Ref: 2114T-03\_GEO

**REACTION ON THE COMMENT OF THE PRE-APPLICATION SCOPING REPORT AND PLAN OF STUDY (“SR&POS”) IN TERMS OF THE NATIONAL ENVIRONMENTAL MANAGEMENT ACT, 1998 (ACT NO. 107 OF 1998) (“NEMA”) AND THE ENVIRONMENTAL IMPACT ASSESSMENT (“EIA”) REGULATIONS, 2014 (AS AMENDED) WITH RESPECT TO THE PROPOSED DEVELOPMENT OF THE NEW WAVE DAM AND ASSOCIATED INFRASTRUCTURE ON PORTIONS 101 AND 168 OF THE FARM MELKBOOM NO. 384, VANRHYNSDORP.**

This report is an addendum to be read with report **2114DDR-S2** by Sarel Bester Engineers.

PROJECT  
**PROPOSED NEW WAVE DAM ON THE FARM MELKBOOM 384, TRAWAL, CLANWILLIAM RD**

DETAIL  
**Contour Layout Plan (Aerial Photo):  
 Test Pit Positions & Profiles**

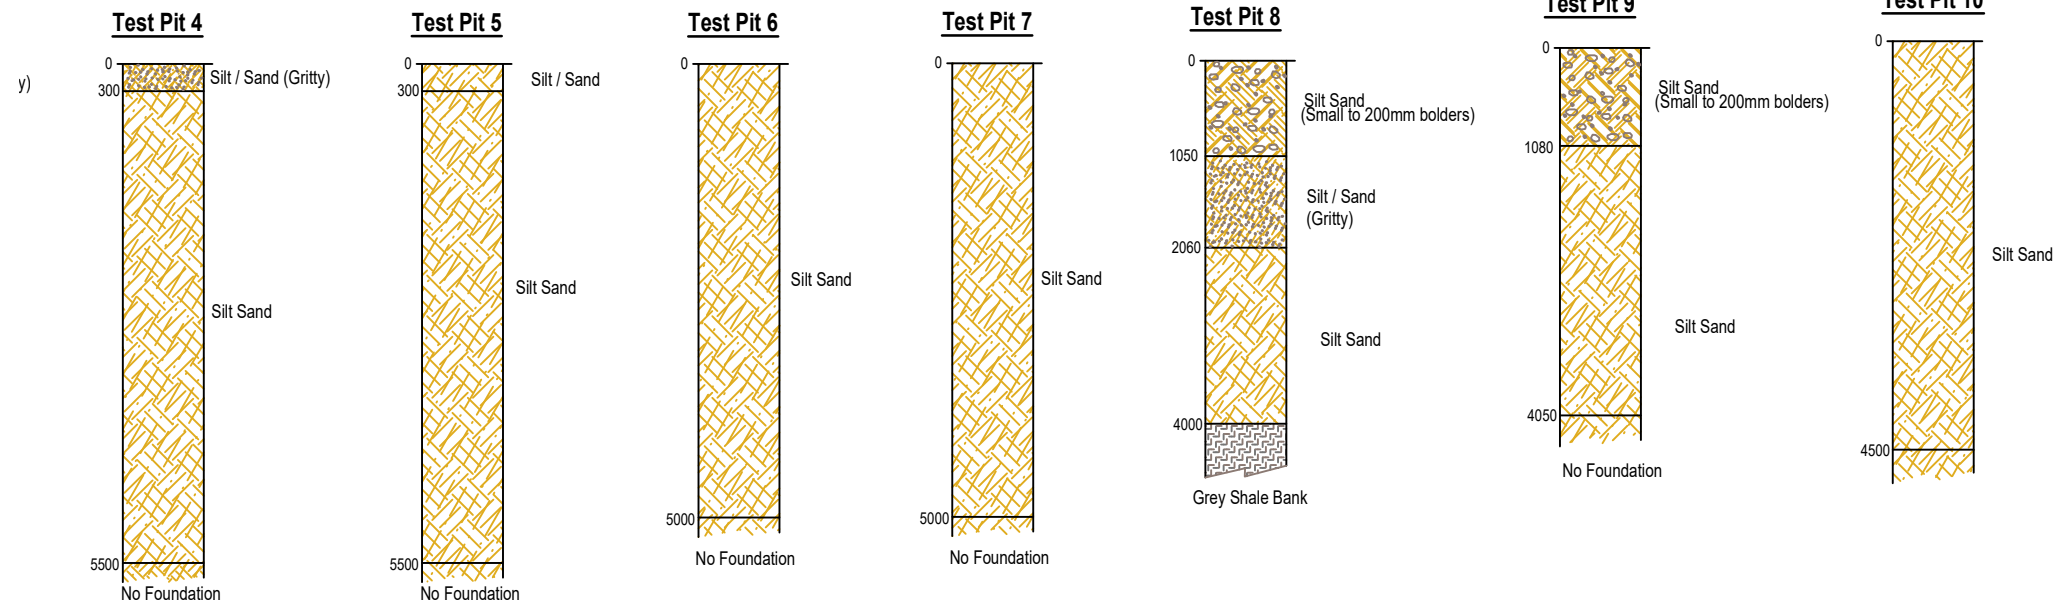
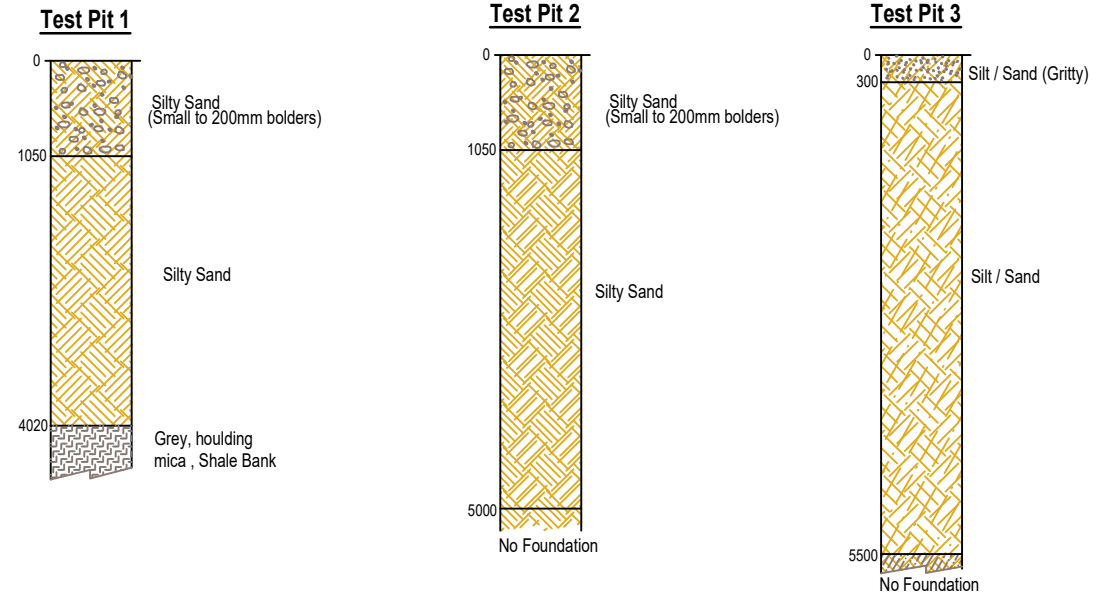
A total of 10 trial pits have been dug on the proposed dam site with 5 along the center line of the footprint of the wall and 5 inside the basin, see **Appendix B**. The aim and purpose of this part of the exercise is to assess the soil profile with regard to expected foundation conditions and sealing potential underneath the dam wall and basin as well as exploration with regard to the types and quantity of material available for use in construction of the embankment.

These soil profiles show a brown topsoil layer of which the thickness varies between  $\pm 0,3\text{m}$  and  $\pm 1\text{ m}$  underlain by red, brown and yellow layers of sandy to loamy material between  $\pm 0,5\text{m}$  and  $\pm 4\text{m}$  deep.
